AMENDMENT SCHEDULE for 125-129 Arthur St, Parramatta - S4.55

This schedule is to indicate all the amendments between current issue and the approved plans.

Amendments are to satisfy flood safety requirements, and address minor changes for CC, due to structure or services
All newly reconfigured units are complied with ADG requirements; room size in meter are noted on the plans. No change to the approved façade material.

125-129 ARTHUR STREET
PARRAMATTA

LANDSCAPE CALCULATION

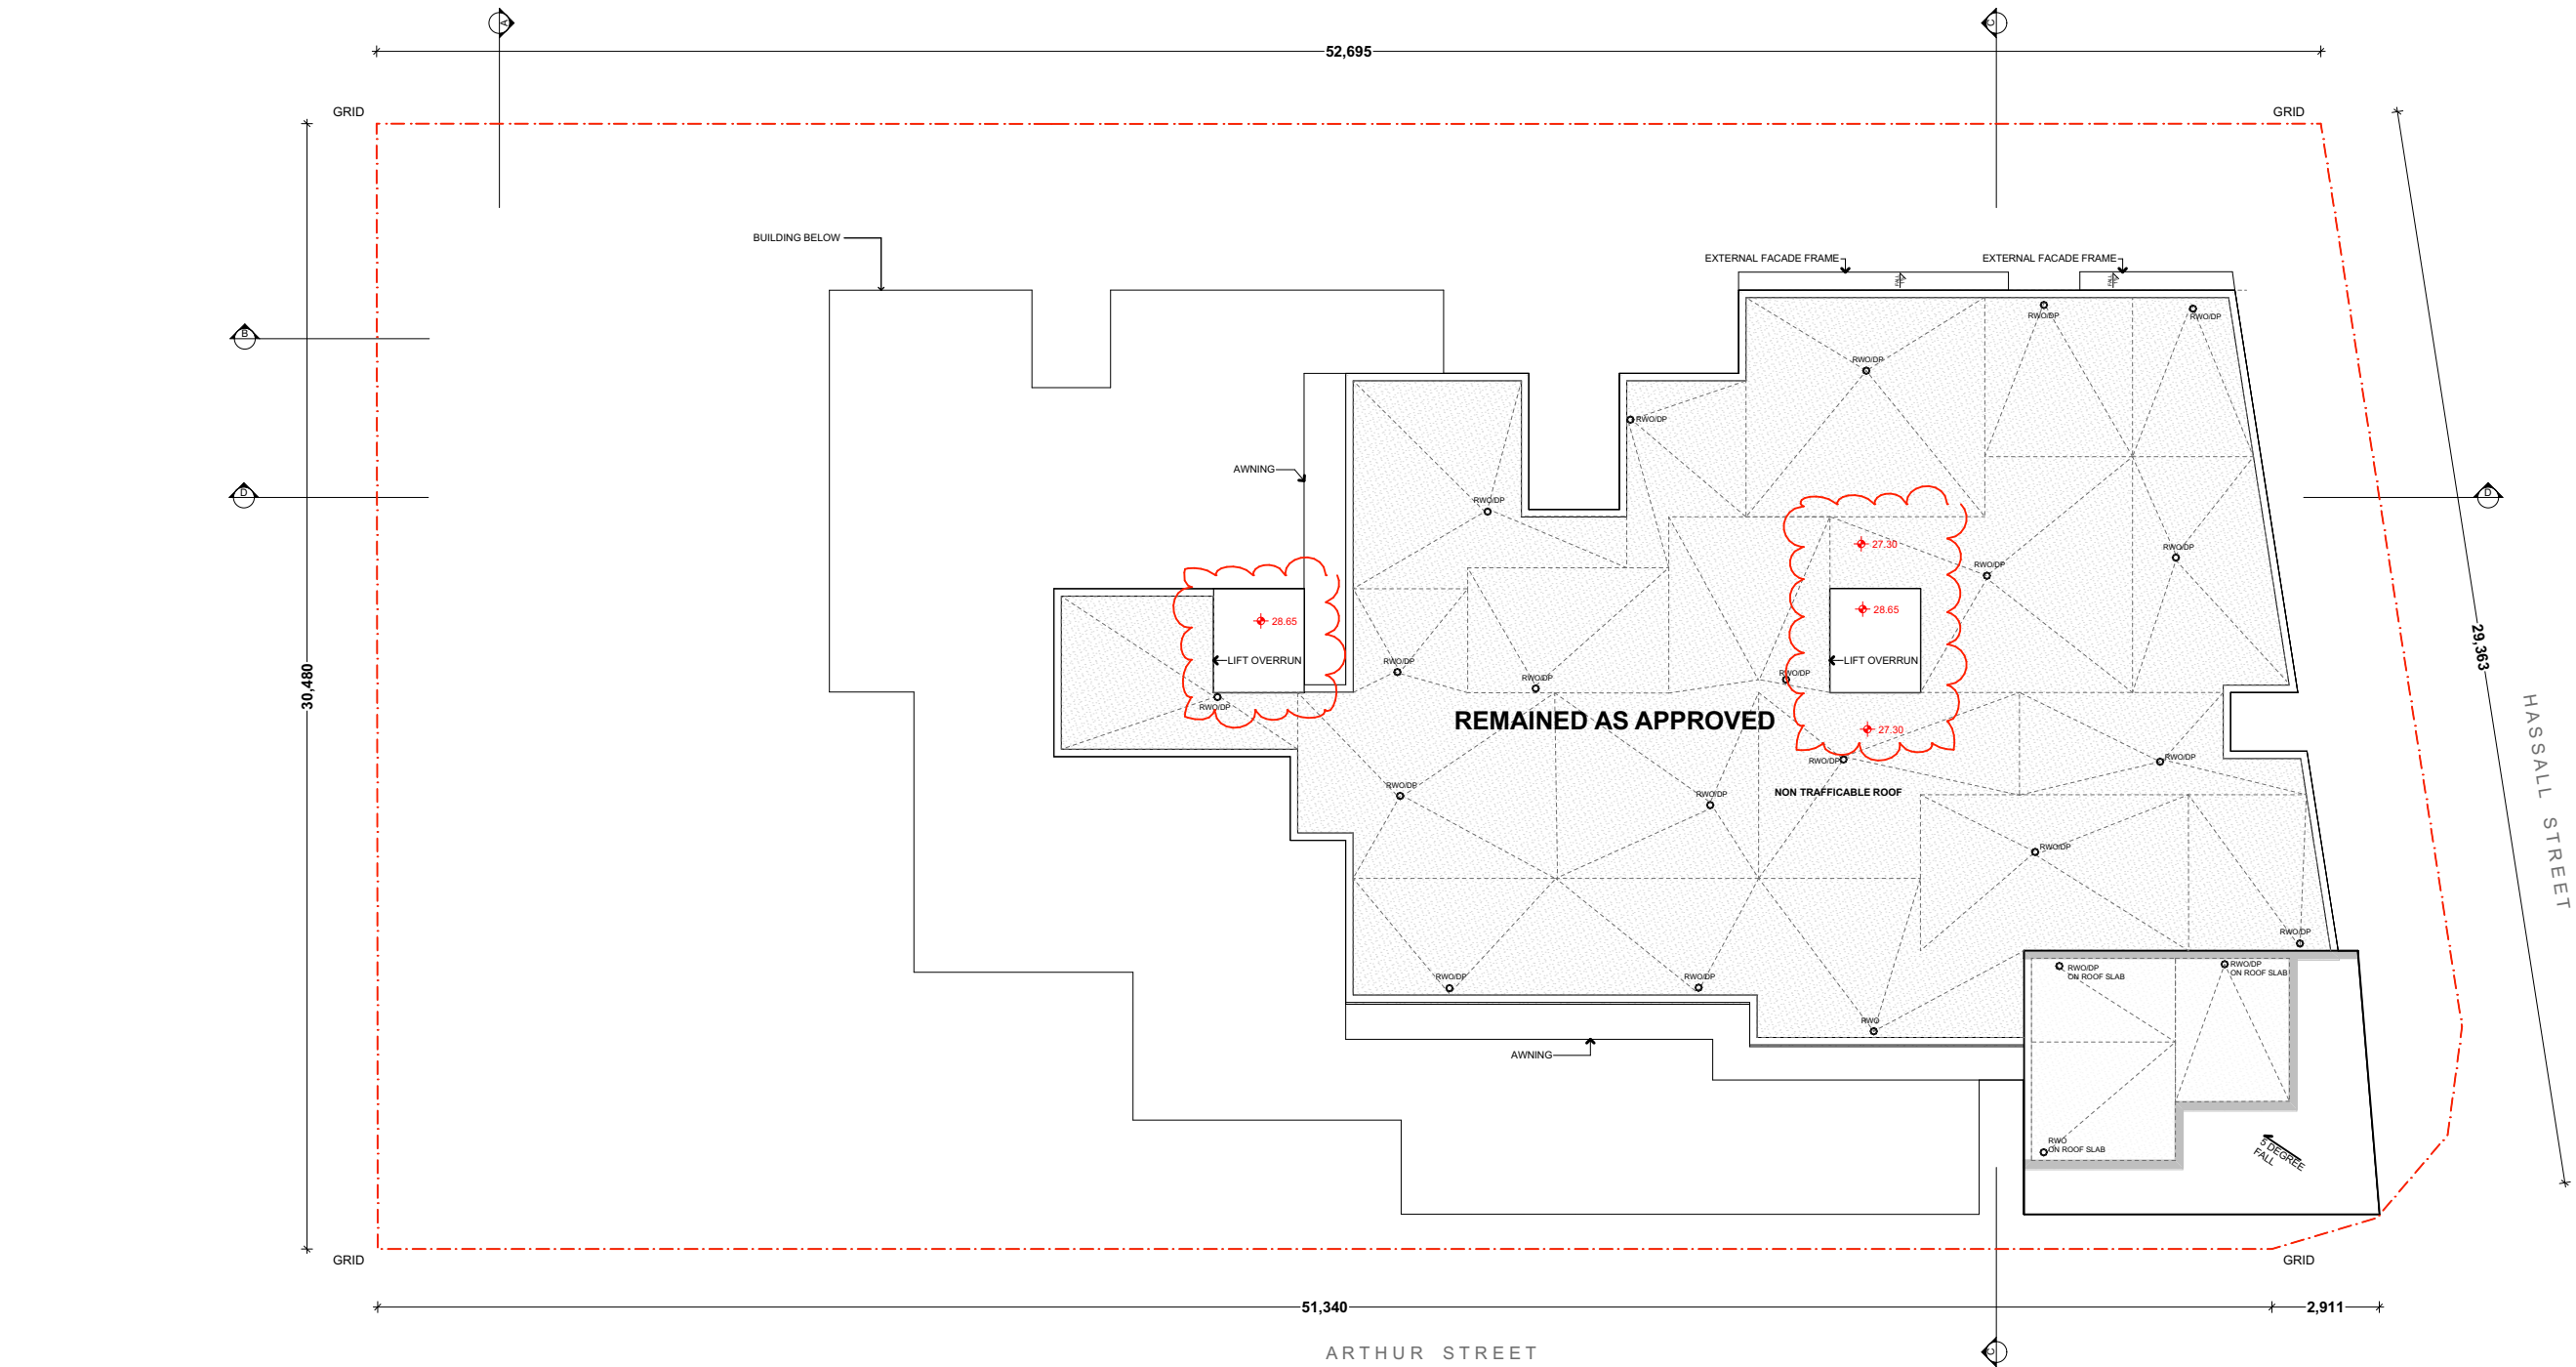
- Landscape and common open space calculations updated

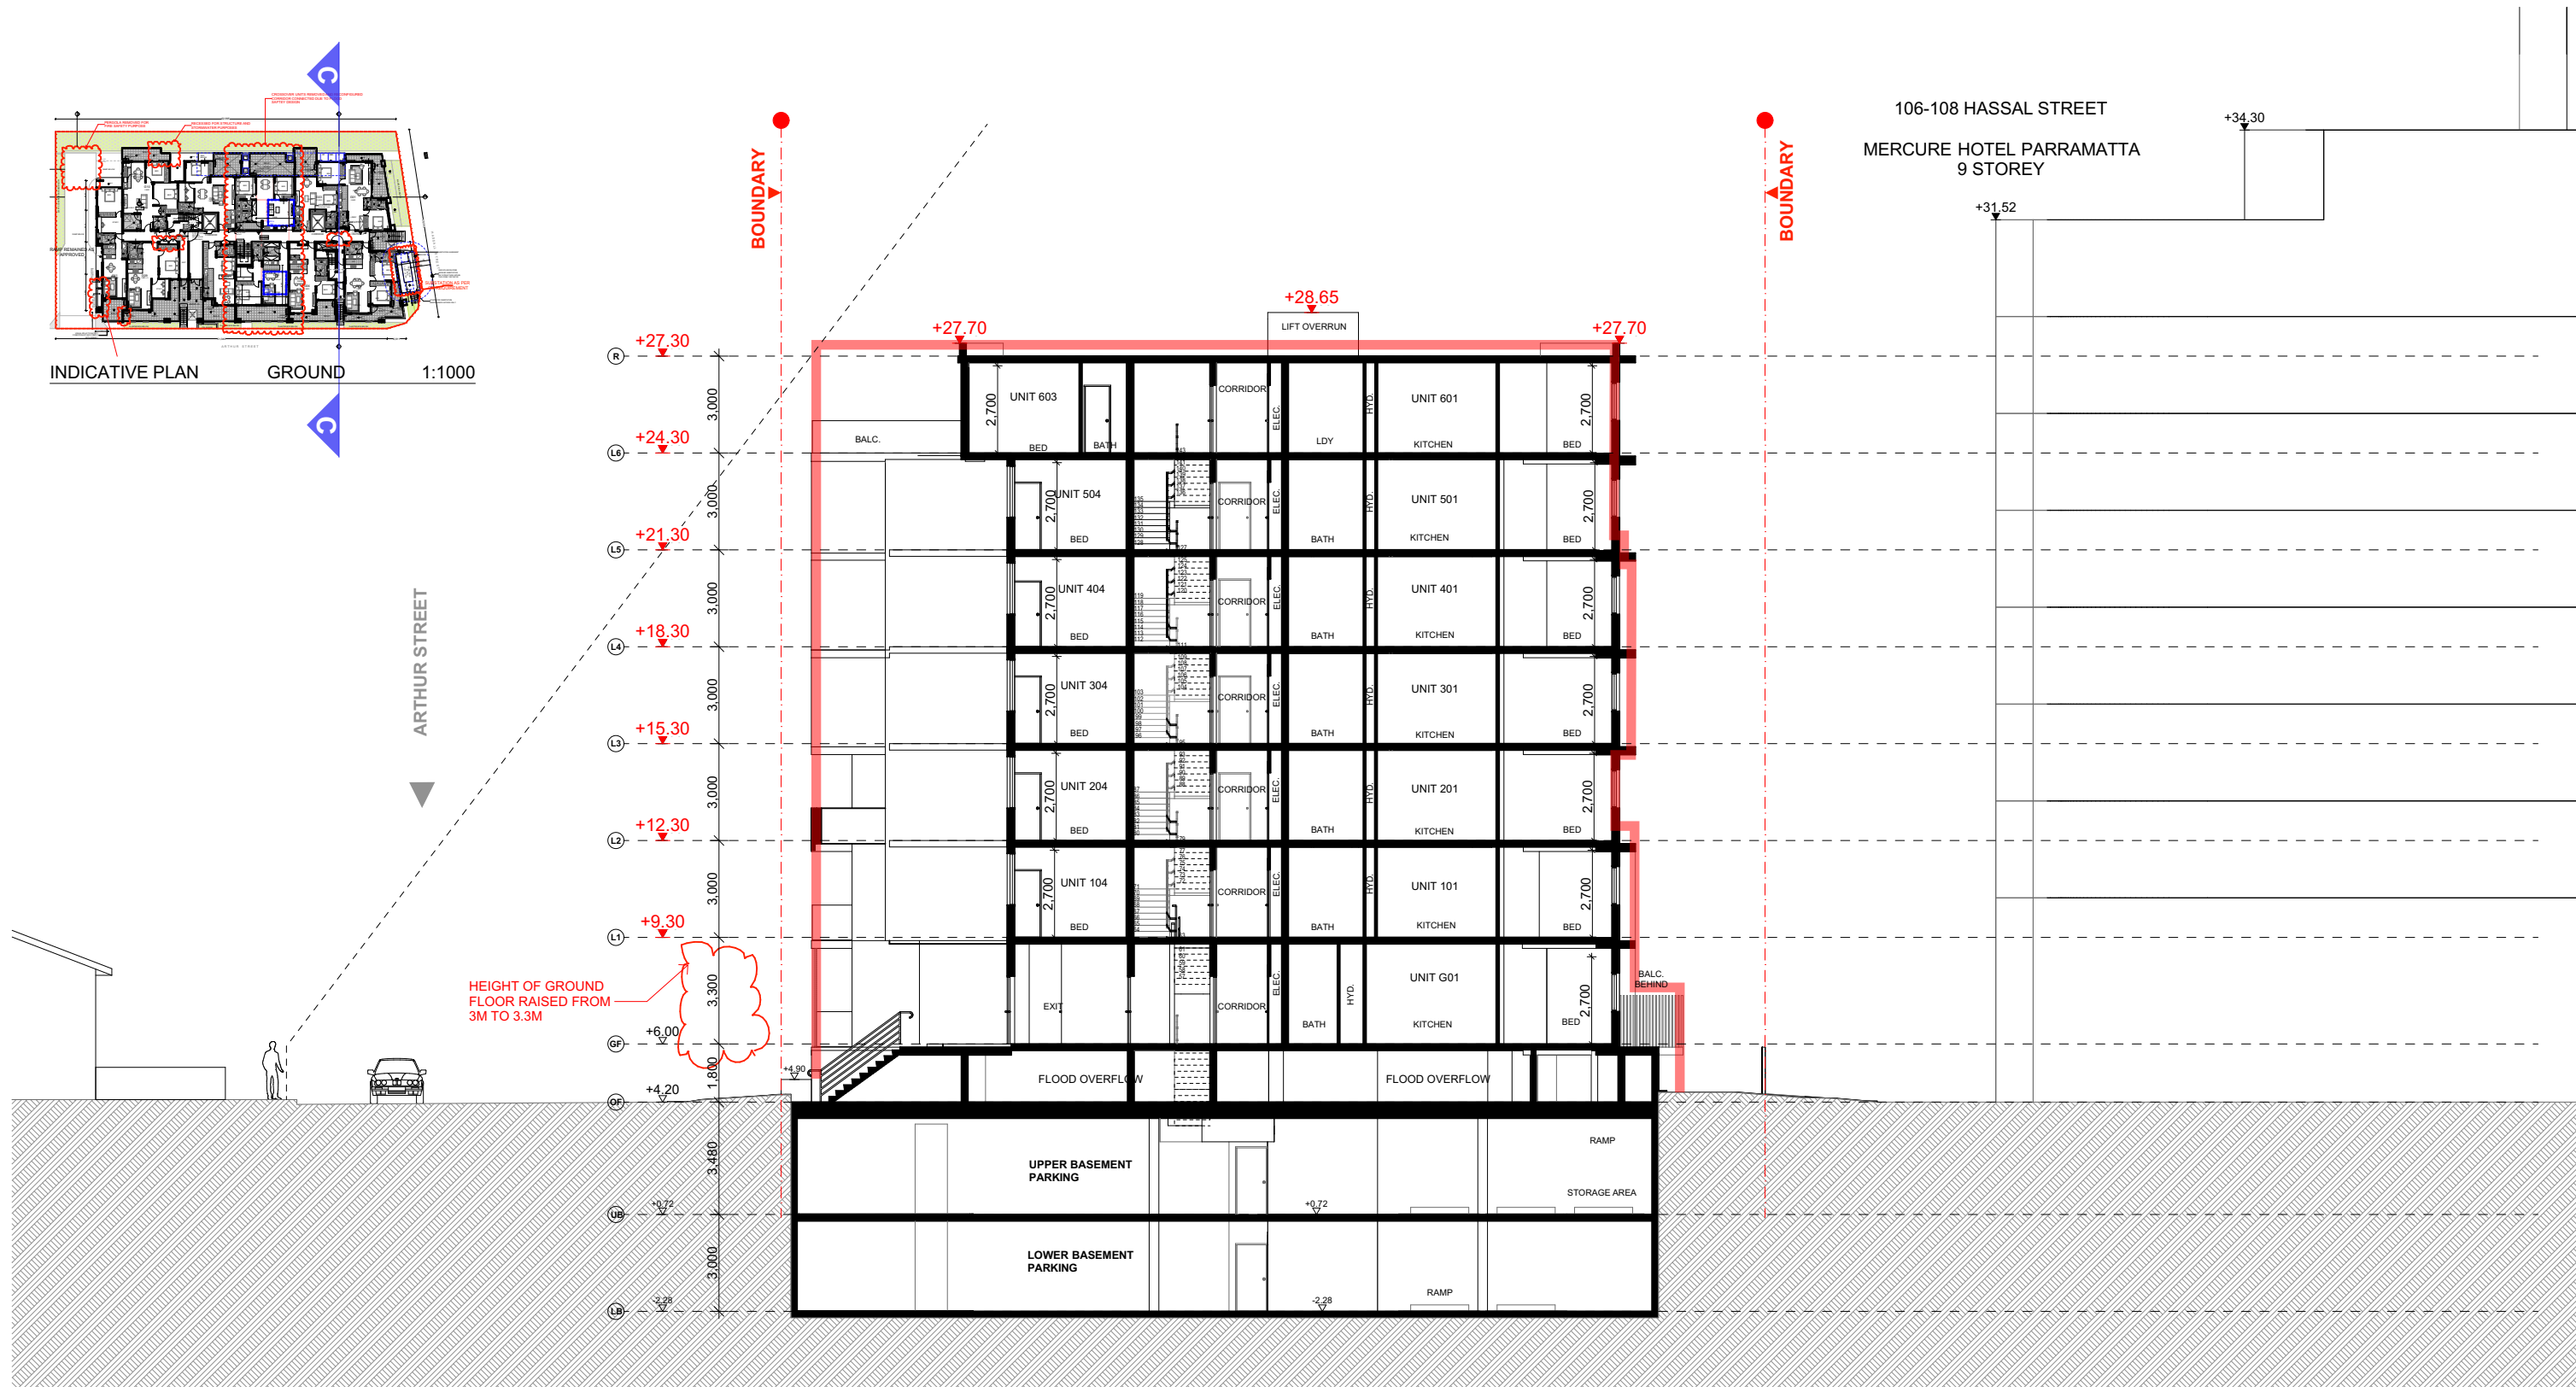
SERVICES UPDATED AS PER CC DESIGN
SUCH AS ADDITION OF HYDRAULIC RISERS/ SERVICE CUPBOARDS
/ MECHANICAL DUCTS

SECTION CC

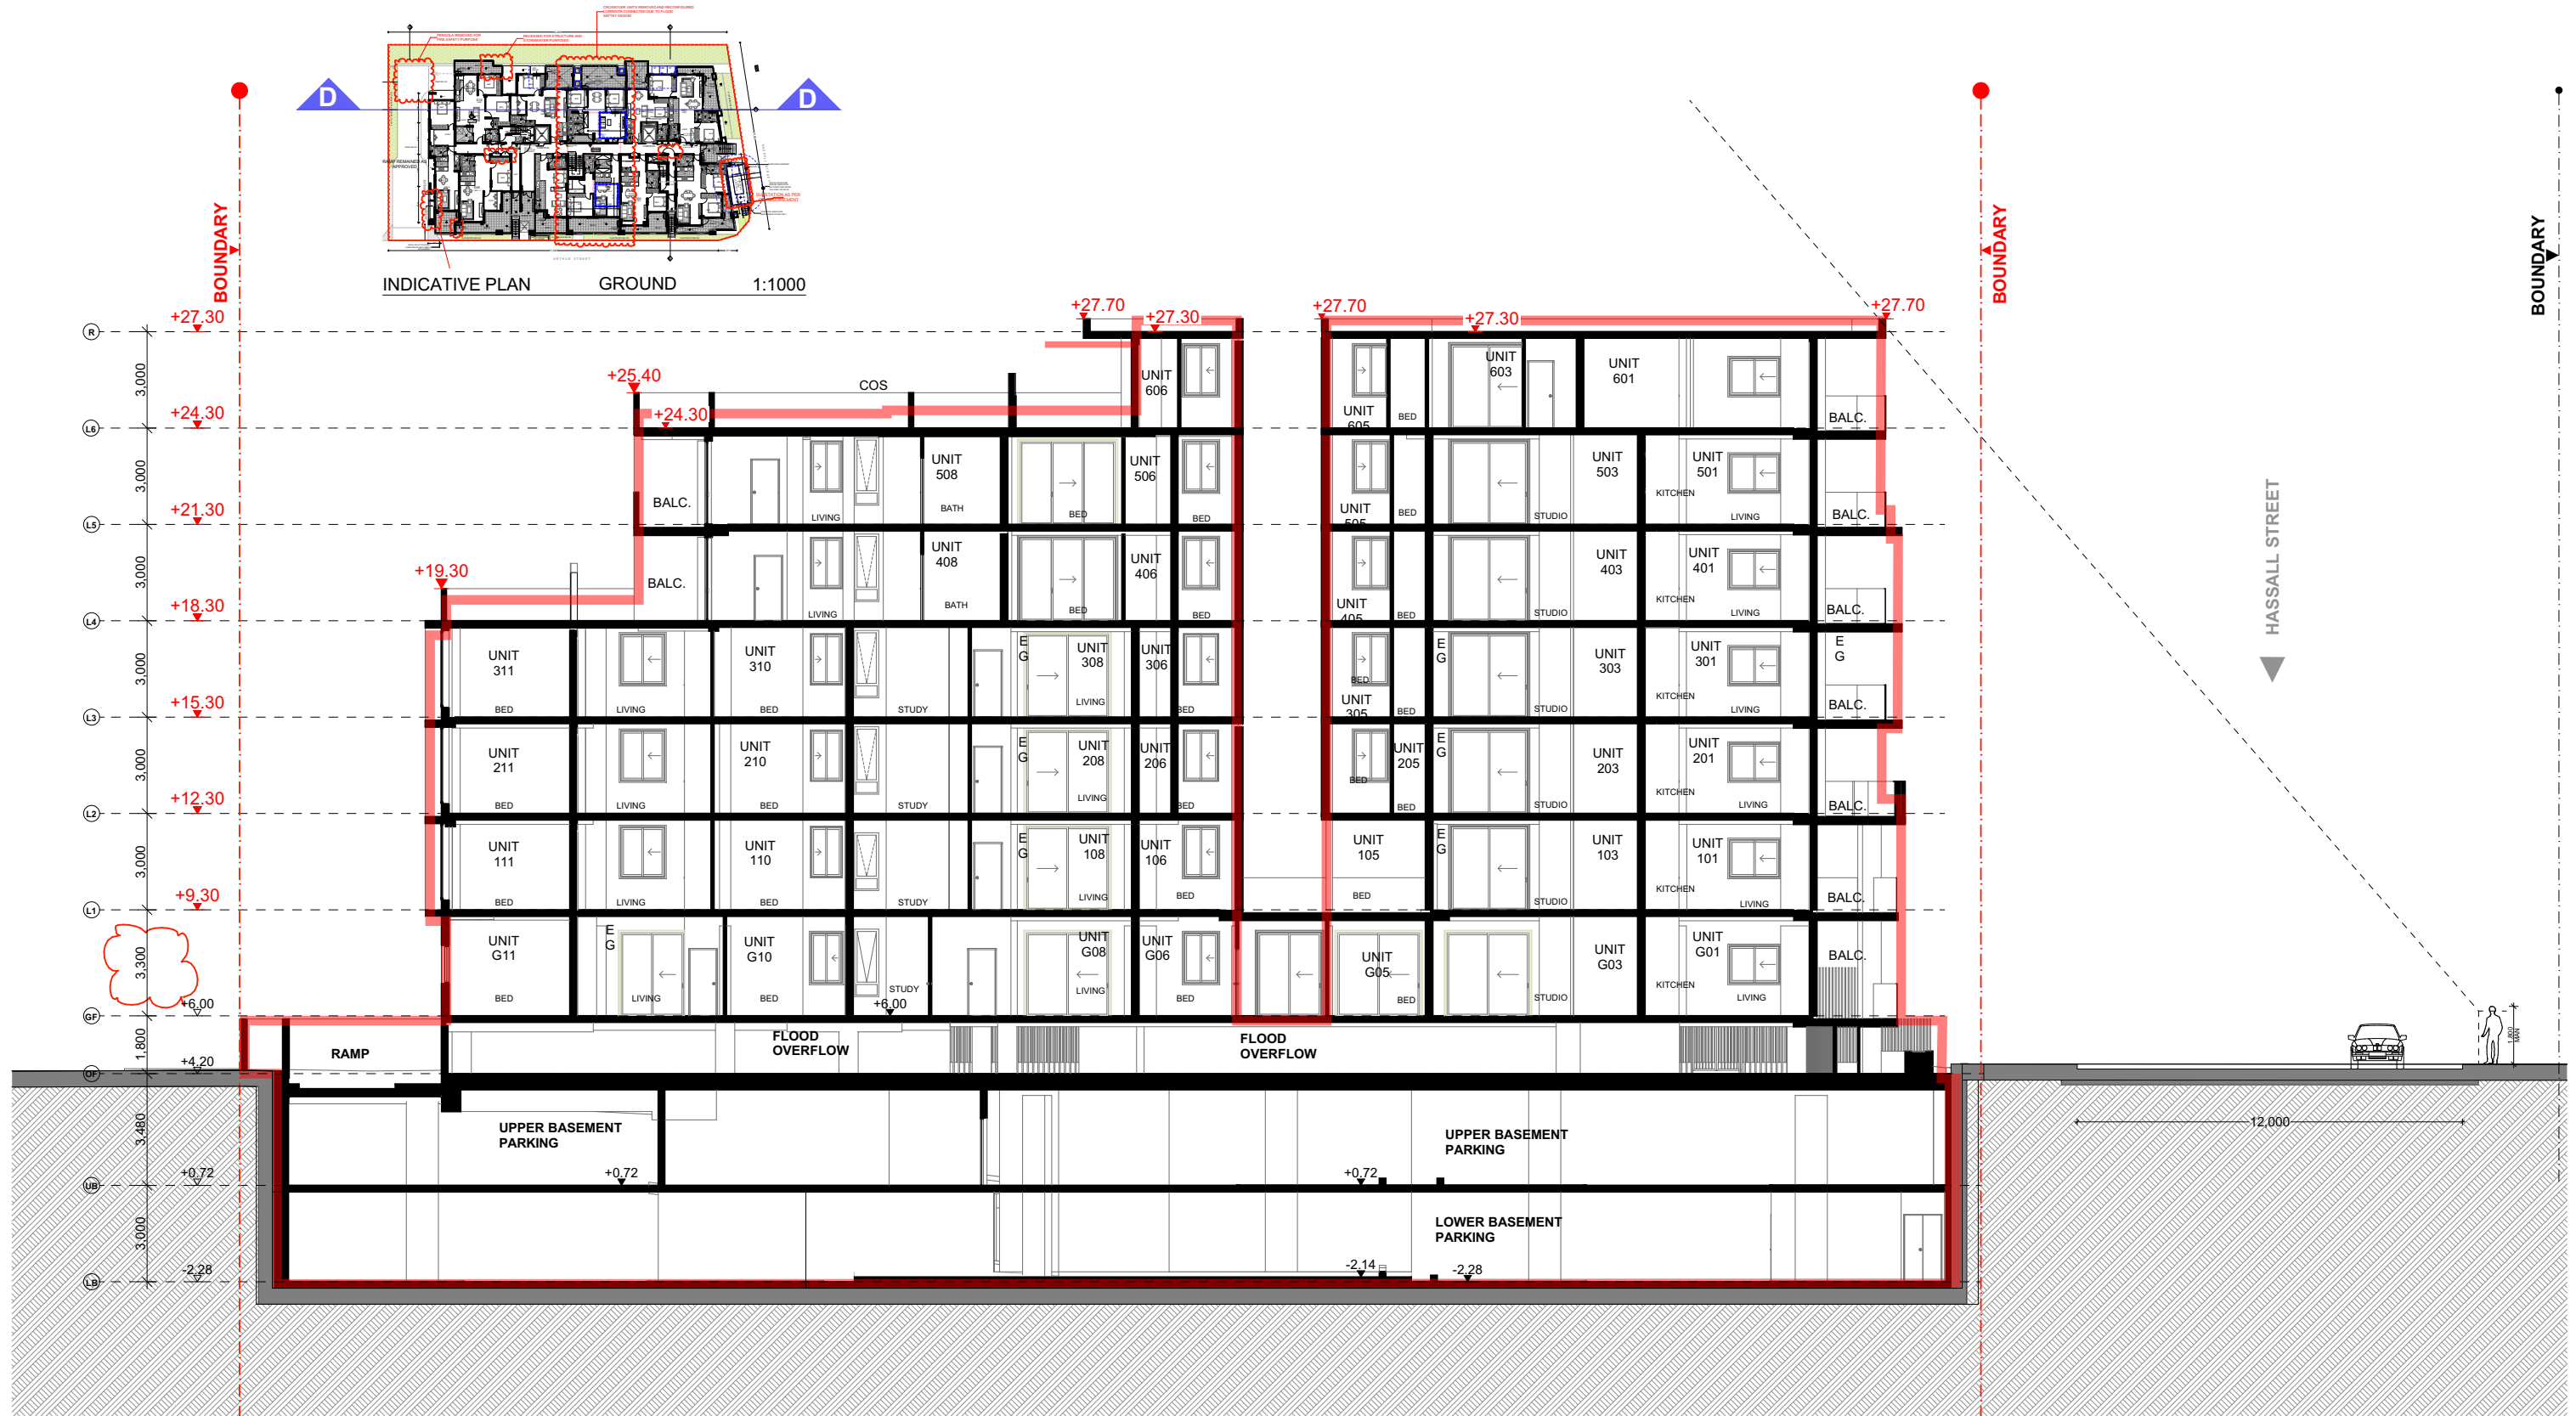
SERVICES UPDATED AS PER CC DESIGN
SUCH AS ADDITION OF HYDRAULIC RISERS/ SERVICE CUPBOARDS
/ MECHANICAL DUCTS
